SERVICE BULLETIN

APPLICABILITY: 2014-2017MY Forester

NUMBER: 10-87-17

SUBJECT: Rattling Sound from Instrument Panel

[A] $t = 0.7\text{mm}$, 12mm x 25mm

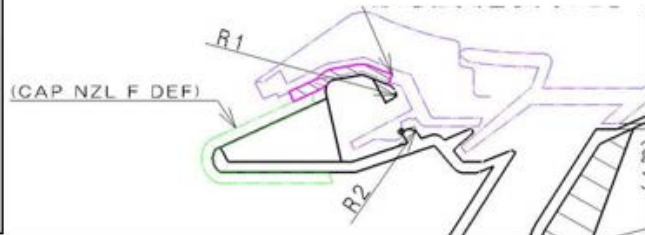
- Using the illustration and photos below, position and apply the tapes [A], [B], [C] & [D] to the defroster duct. Tapes may be layered or stacked to achieve the desired thicknesses.

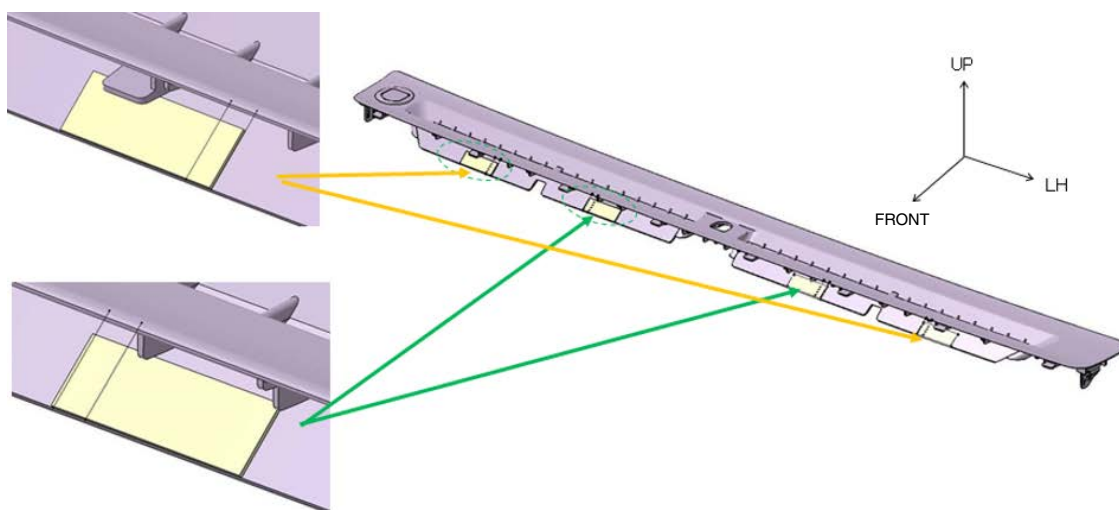
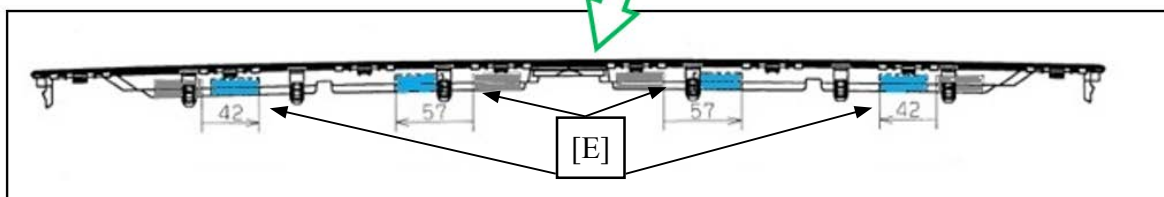
- Using the illustrations below, position and apply the 4 new tapes [E] to underside of the defroster vent grille. The dimensions for the tapes (shown in blue in the first illustration) are:
[E] t = 0.7mm, 12mm x 35mm and may also be layered or stacked to achieve the desired thicknesses.

NOTE: The 42mm and 57mm dimensions shown in the illustration are approximate measurements to help with proper positioning of the tapes.
